ADDENDUM NO. 1
FOR
TKI TAXIWAY A REHABILITATION PHASE II
26-46ITB

ISSUED
April 20, 2026

TKI TAXIWAY A REHABILITATION PHASE II 26-46ITB

McKinney National Airport (TKI) Taxiway A Rehabilitation Phase II BID NO 26-461TB Pre-Bid Meeting Minutes

DRAWING NUMBER
CD102
 SHEET NUMBER
28

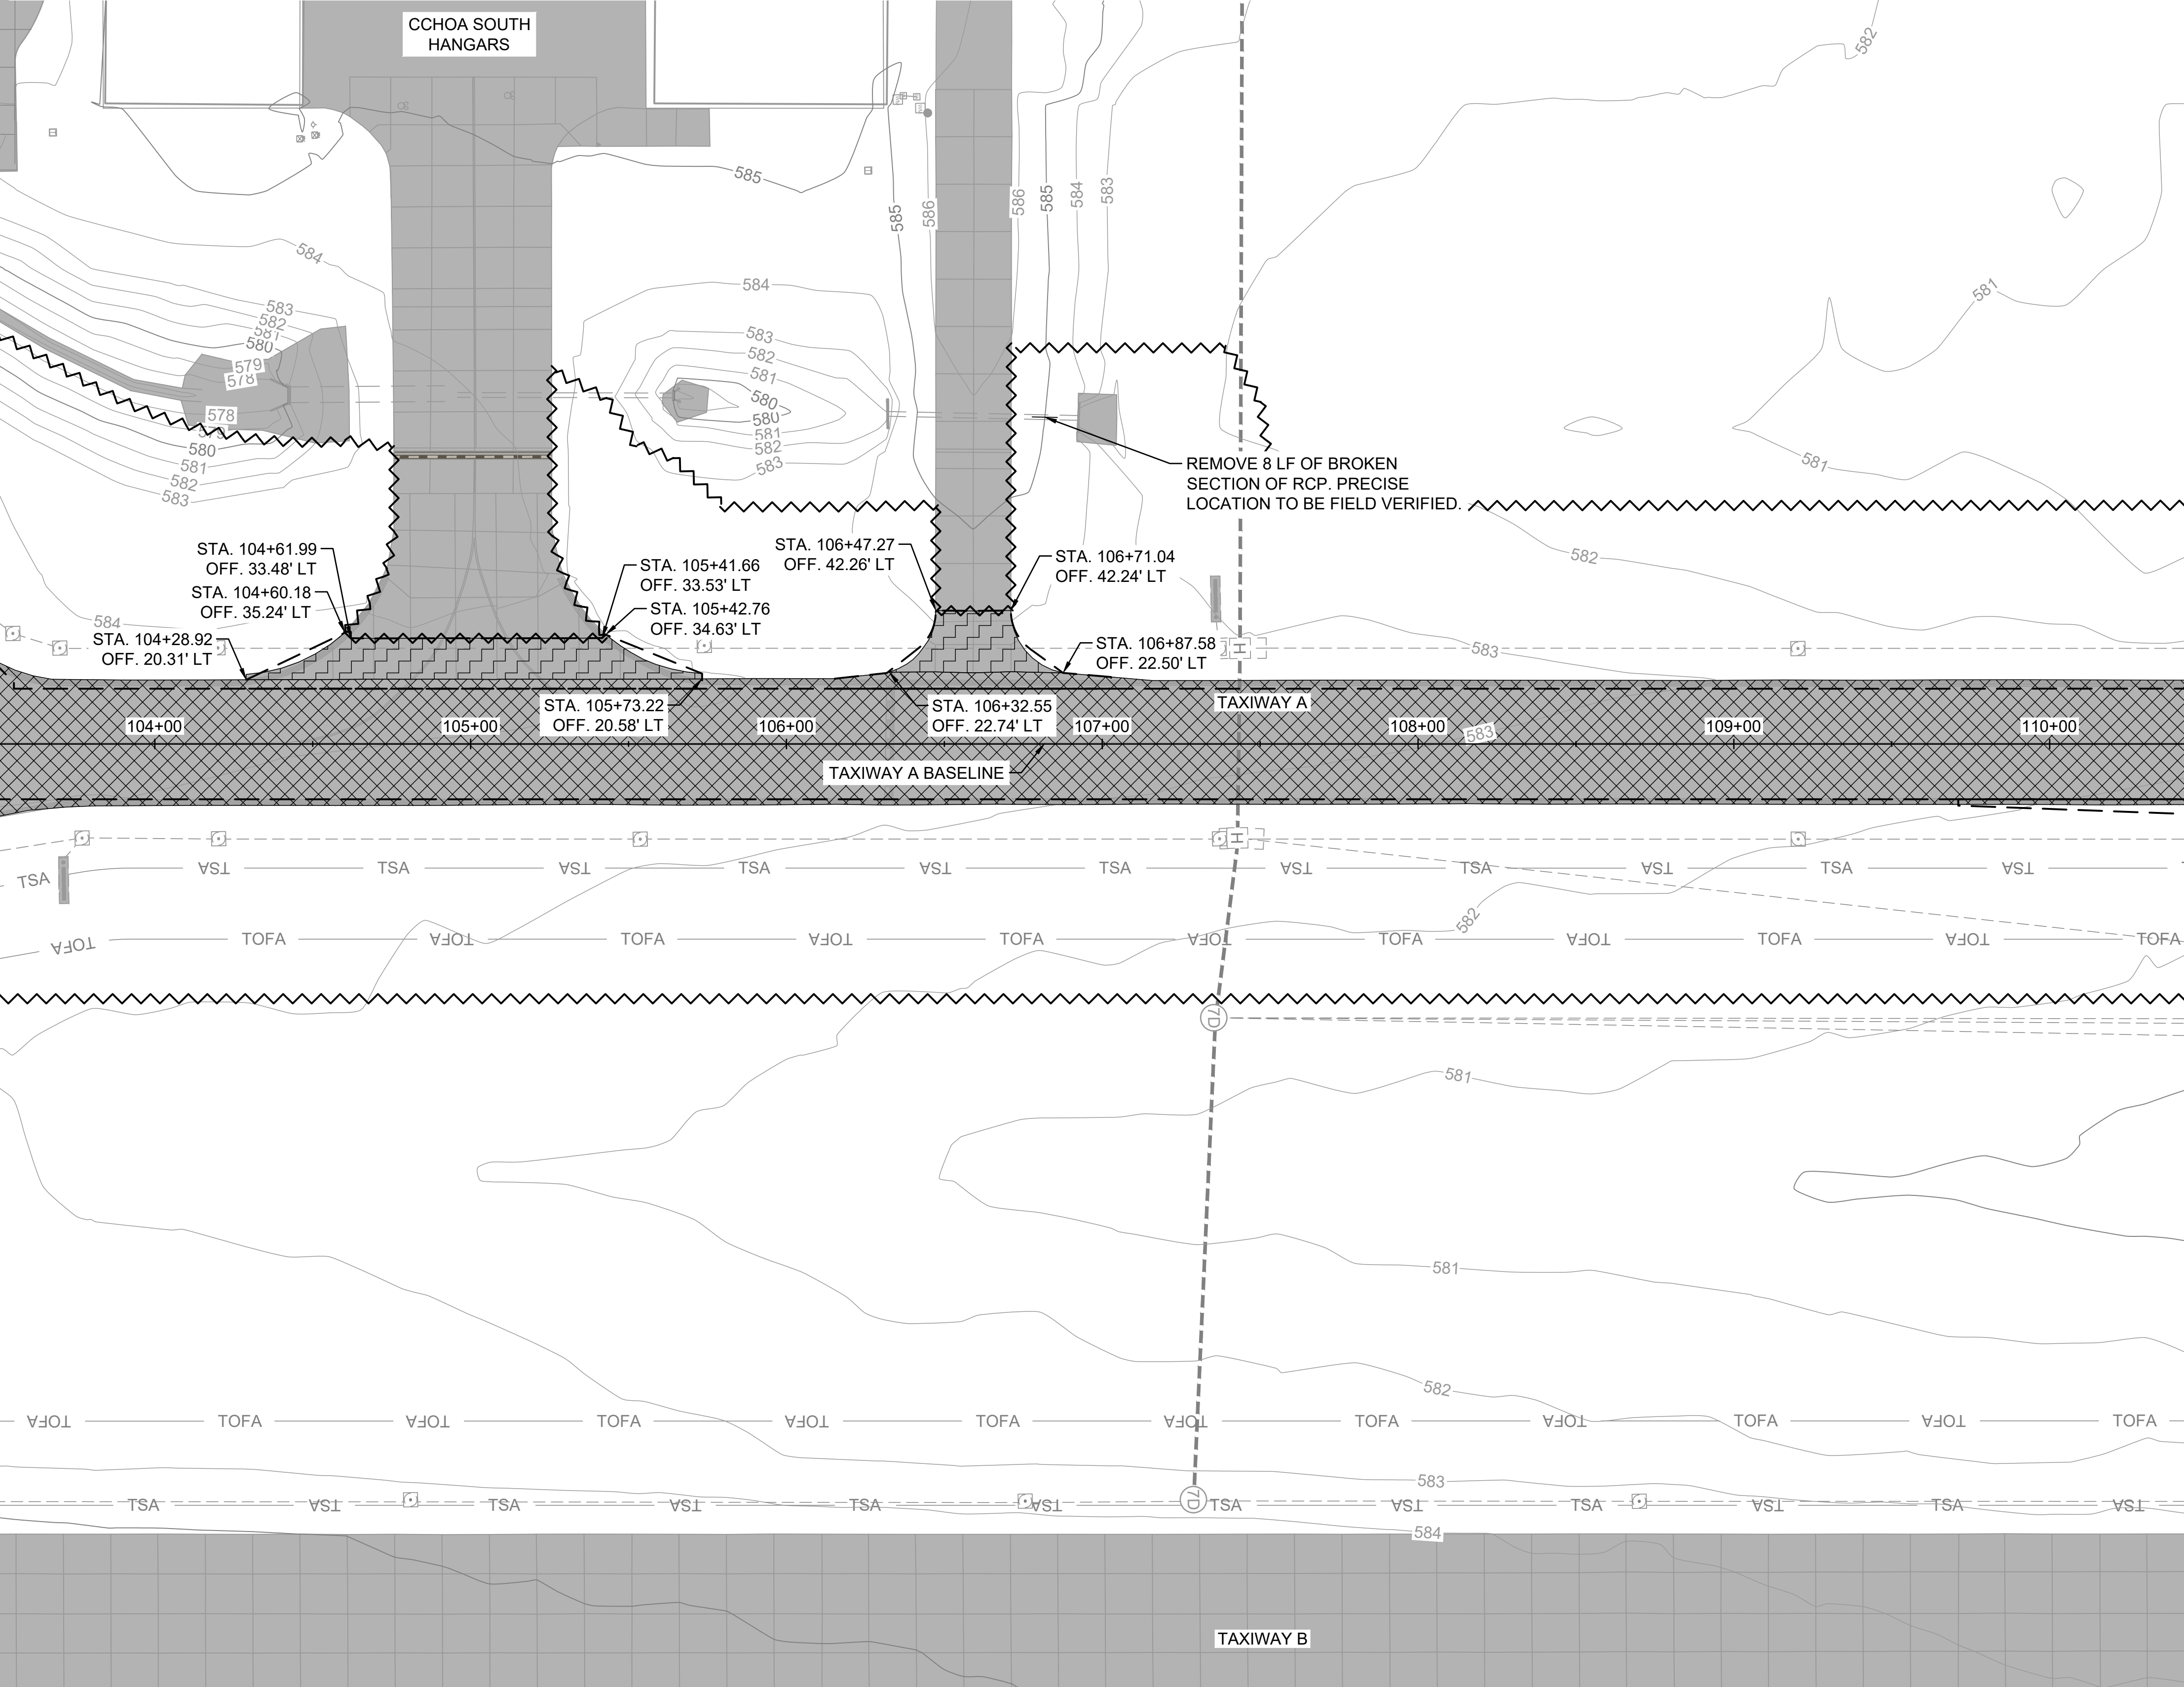
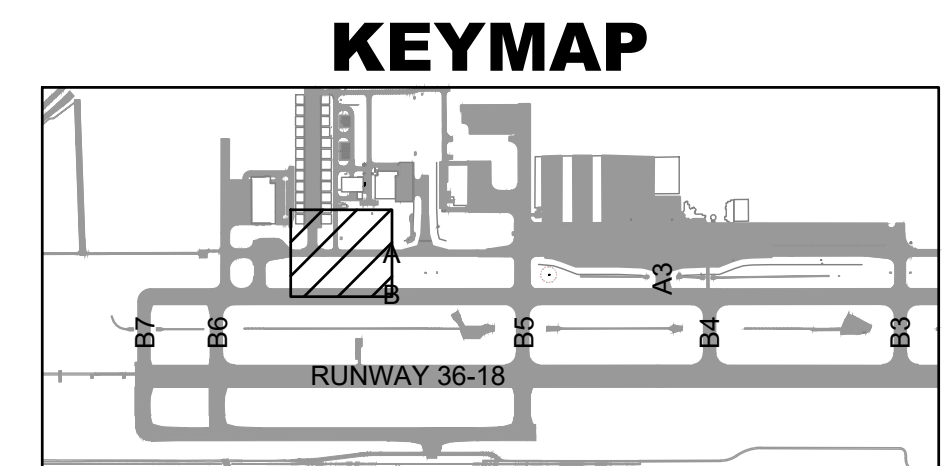
8. Graphics are missing from the demolition sheets, please provide updated sheets.

Answer: *Updated sheets provided*

1 NEW GUIDANCE SIGN INDEX
 EL505 SCALE: NONE

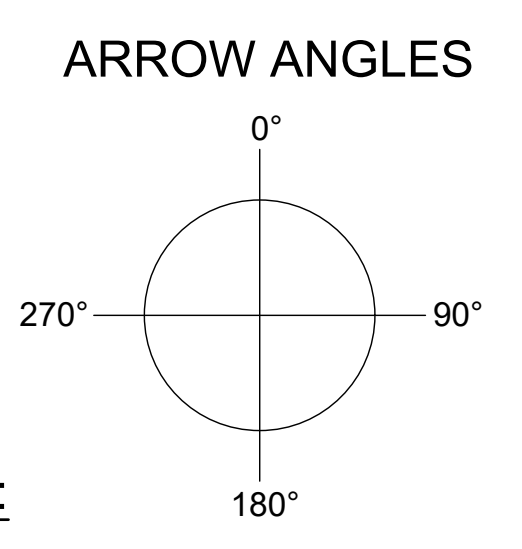
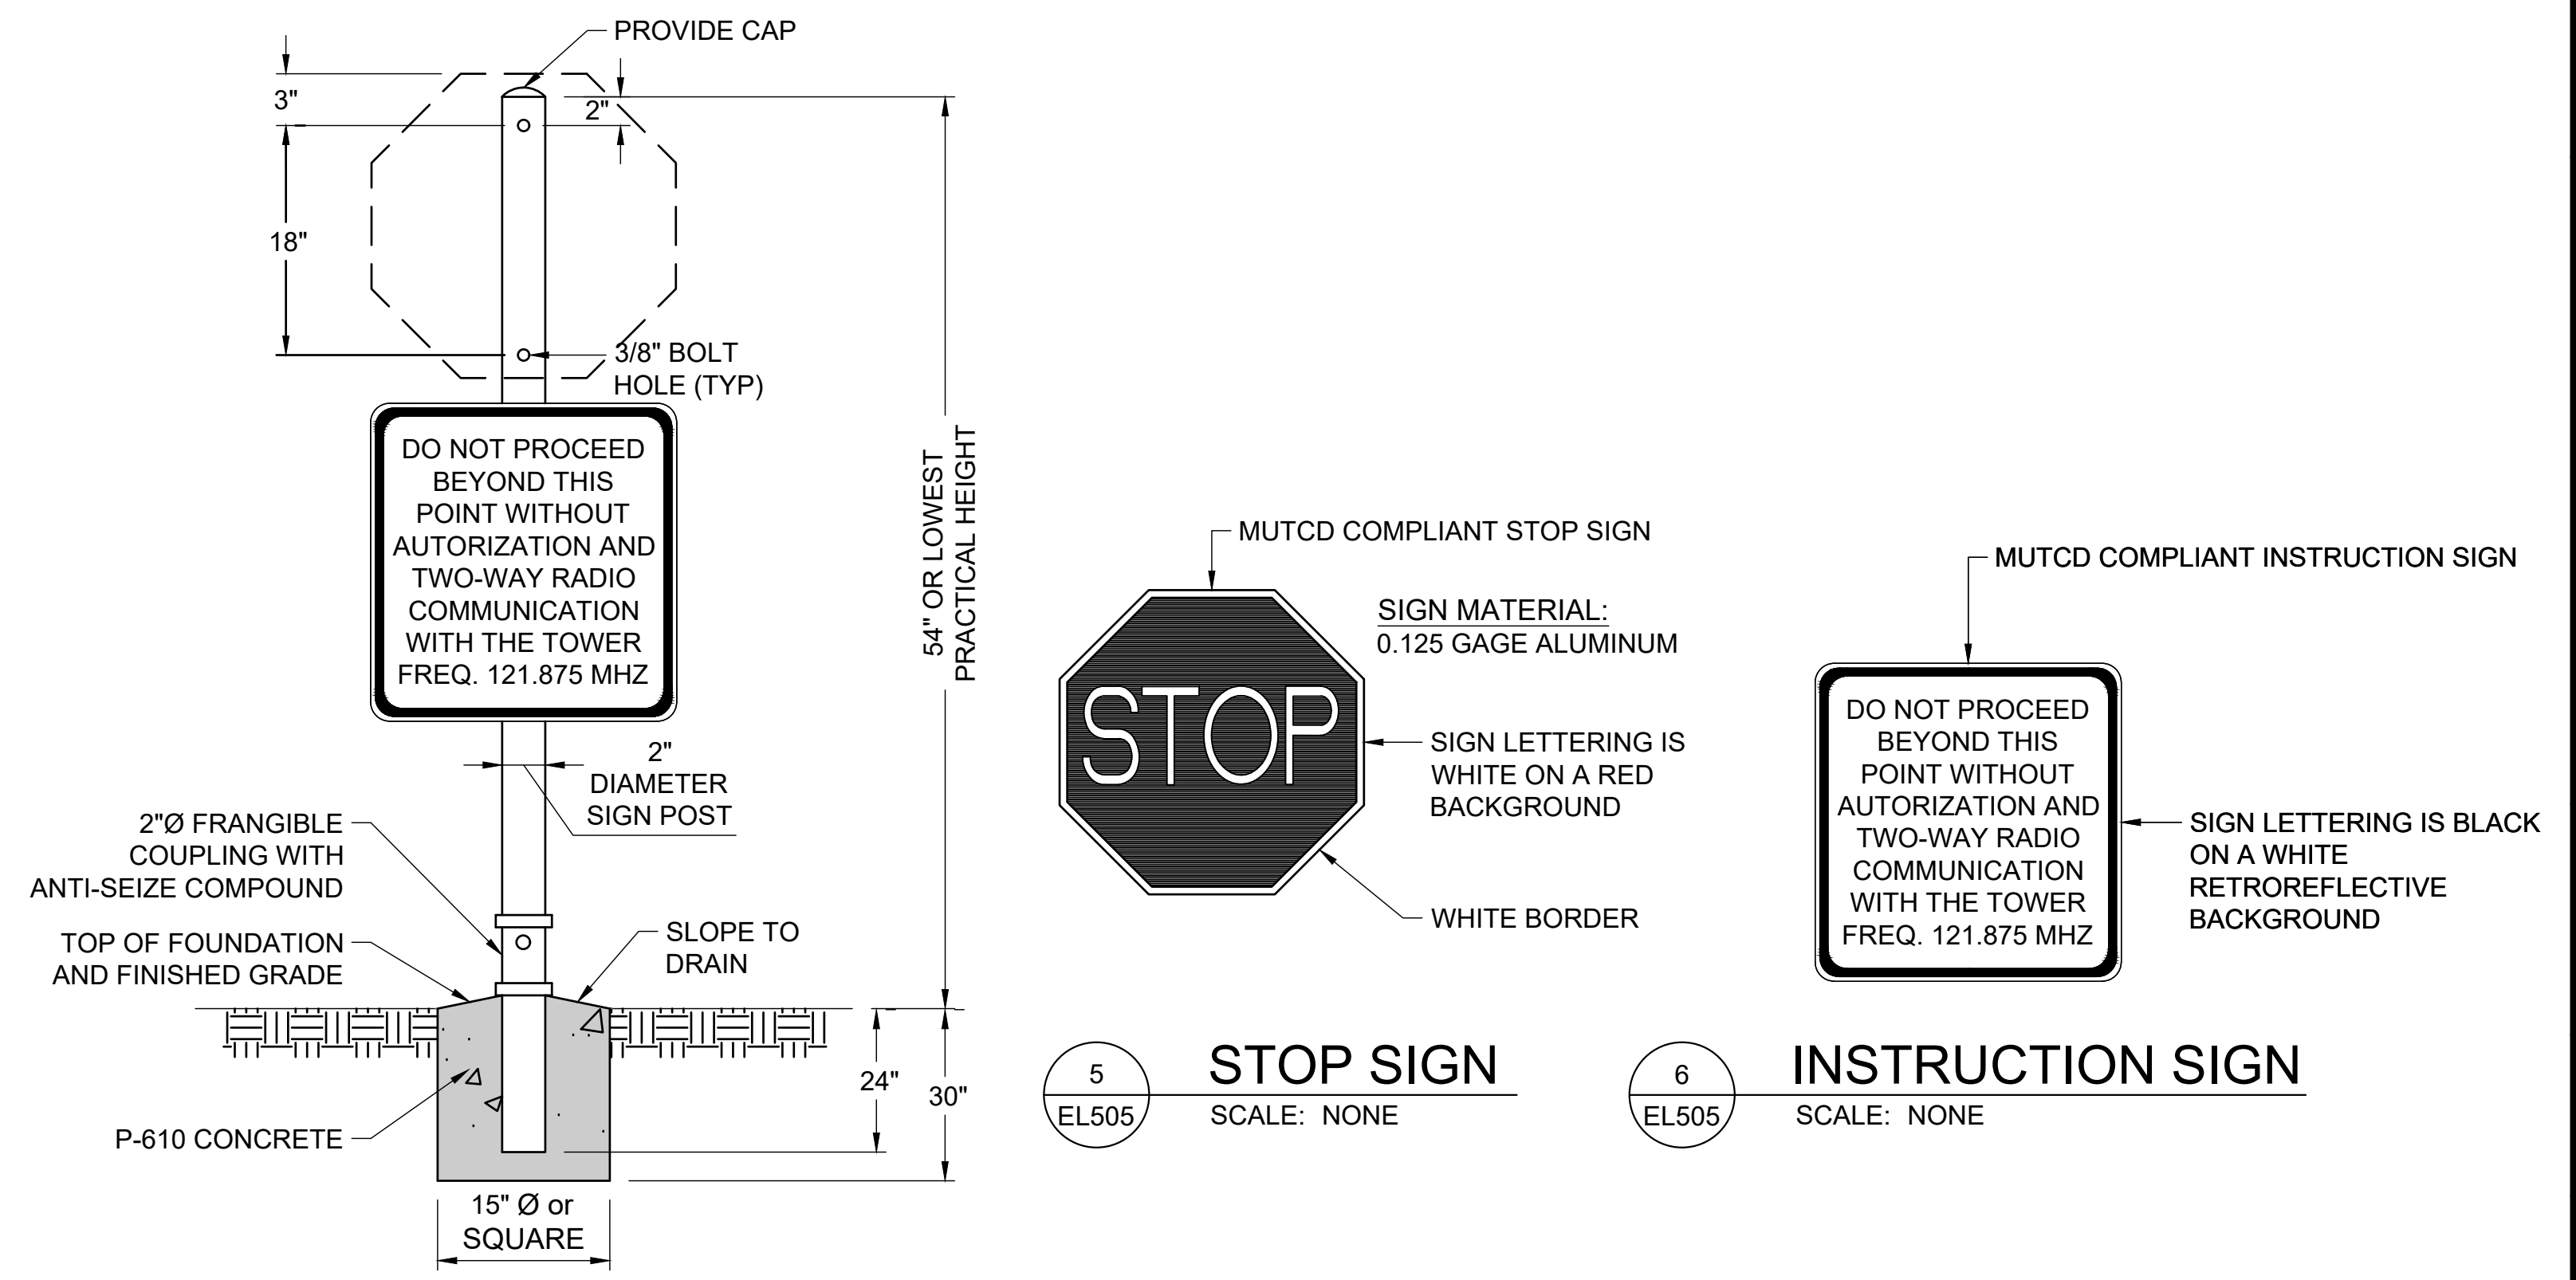
3. Sign schedule shows ten 3-module signs; Bid schedule shows only nine 3- module signs. Sign #6, which appears on the sign schedule, does not appear in the electrical layout.

Answer: *The quantity for 3-module signs is nine, and quantity for 2-module signs is one. The quantity for sign panel replacement is eight, Sign #6 is sign panel replacement.*
